PROJECT: iMX31-10	
PART NUMBER: 1004734	
ASSEMBLY NAMEiMX31-10 SOM	
SCHEMATICS: KTL,NJK	
TABLE OF CONTENTS	
PAGE	DESCRIPTION
1	TITLE PAGE AND BLOCK DIAGRAM
2	CONNECTORS
3	WEIM BUS BUFFERS
4	MX31/DDR RAM
5	FLASH
6	WIRED LAN
7	LOGIC/ADC
8	MX31/UARTS/CODEC
9	MX31/CSI/KEYPAD/USB PHYS
10	MX31/LCD/JTAG/SD1
11	MX31/ATLAS POWER
12	MX31/RST/BOOT/NF/PCMCIA
13	TESTPOINTS
14	ECO LIST

Title iMX31 LV-SOM		Project MX31-10
Number 1004734	Rev 11	Sheet 4 Of 14

10 - MX31/LCD/JTAG/SD1

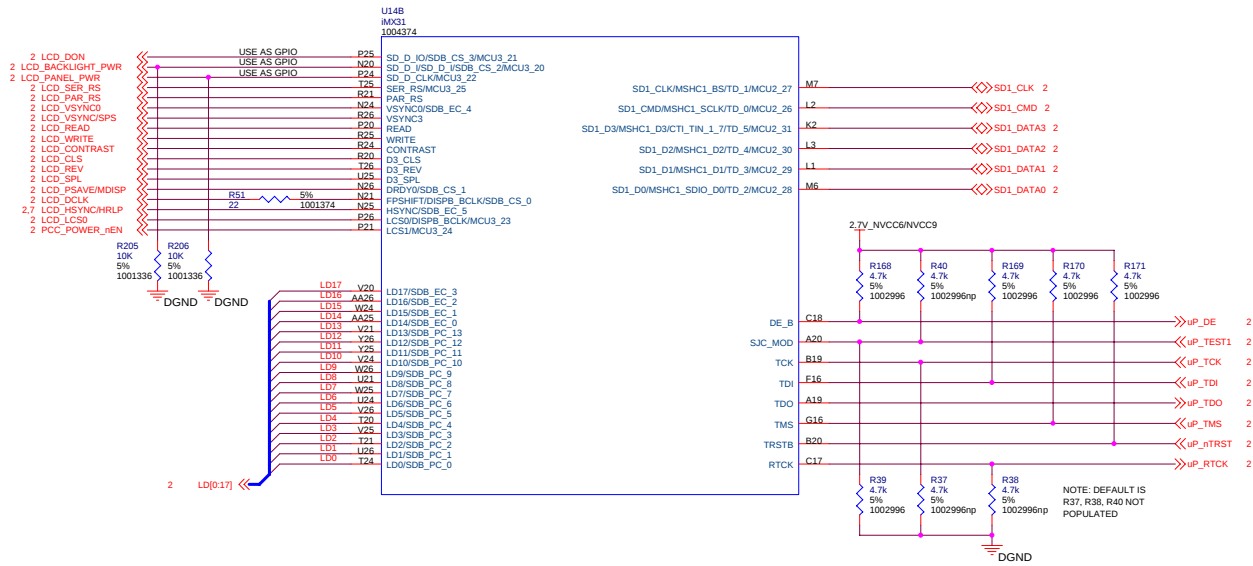
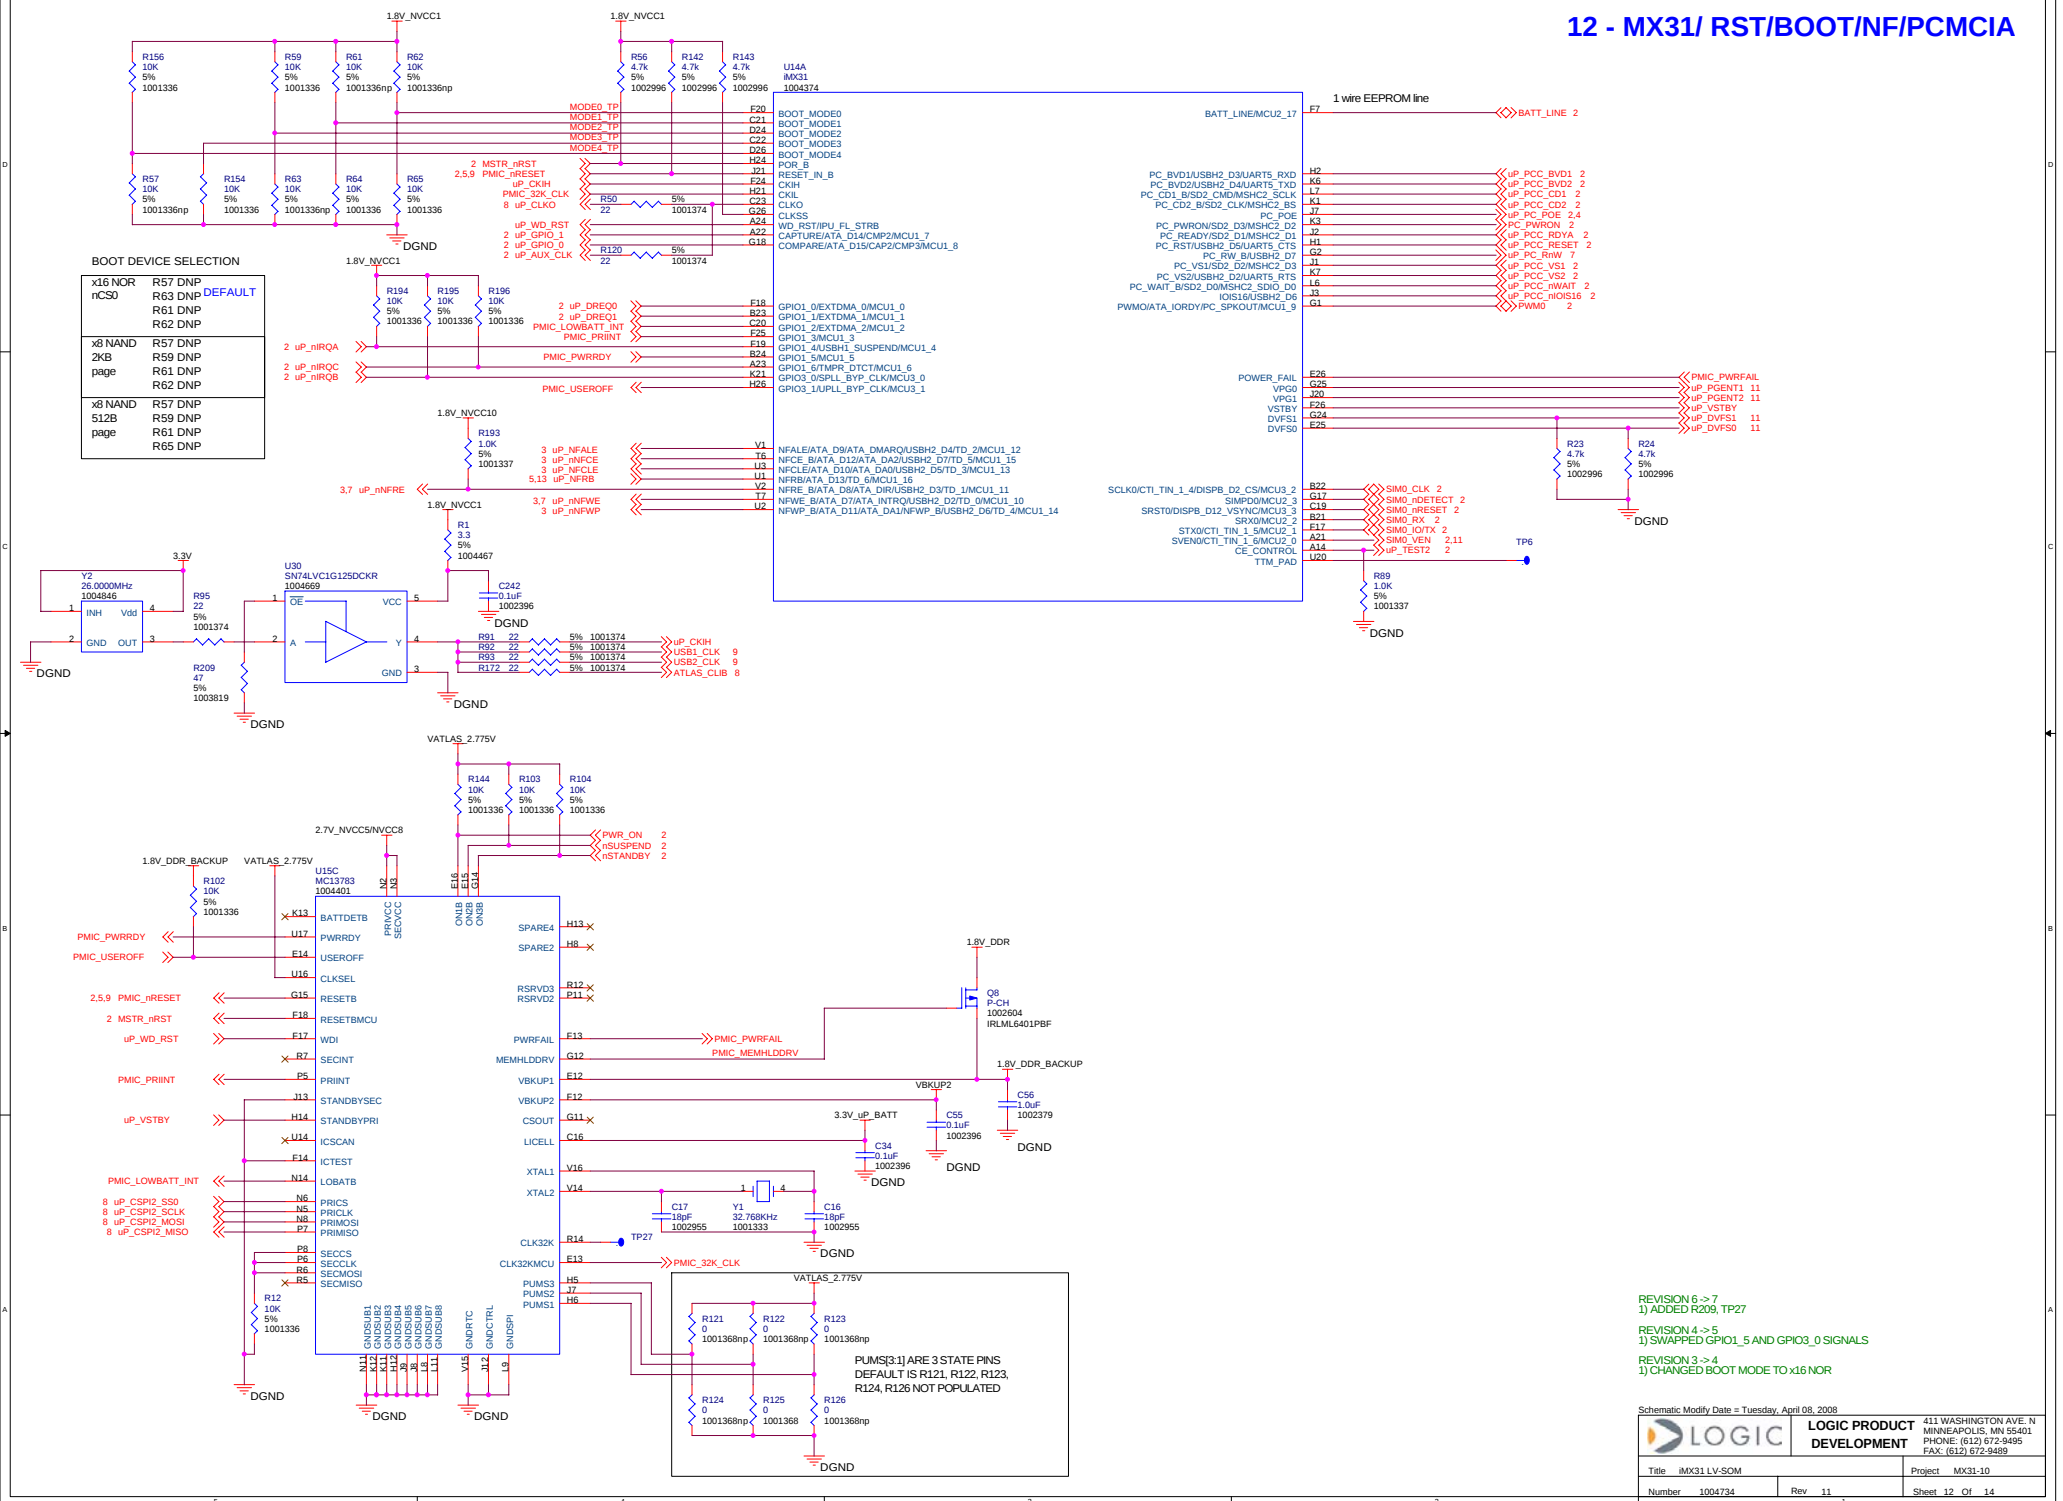
REVISION 6 -> 7
1) ADDED R205 AND R206 TO DISABLE LCD BACKLIGHT AT POWER ON.

REVISION 5 -> 6
1) CHANGED LCD_LCS1 TO PCC_POWER_rEN

REVISION 3 -> 4
1) CHANGED LCD_CONTACT TO LCD_CONTRAST
